CITY OF STAR

LAND USE STAFF REPORT

FILE(S) #: FP-25-05 Final Plat, Stardale Place Subdivision

PRELIMINARY LANDSCAPE PLAN

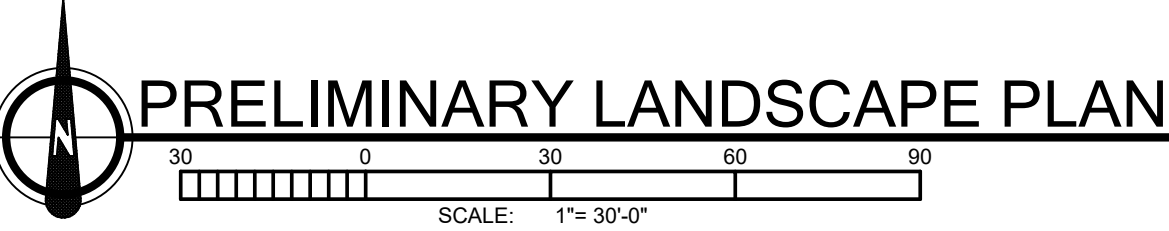
Landscaping - As required by the Unified Development Code, Chapter 4, Section B-7-C-3 Street Trees; the minimum density of one (1) tree per thirty-five (35) linear feet is required. The landscaping plan as submitted appears to satisfy this requirement. The applicant shall use "Tree Selection Guide for Streets and Landscapes throughout Idaho", as adopted by the Unified Development Code. **The included landscape plan appears to satisfy the tree requirements. The plan indicates native seeding in the park/open space. The applicant shall update the landscape plan and include grass within the open space area. The updated plan shall also detail the site amenities, including a gazebo and park benches.**

- 7. Prior to signature of final plat, the applicant shall submit a revised landscape plan removing the native seeding and showing grass within the park/common area lot. The plan shall also detail the 2 site amenities (gazebo & benches).**
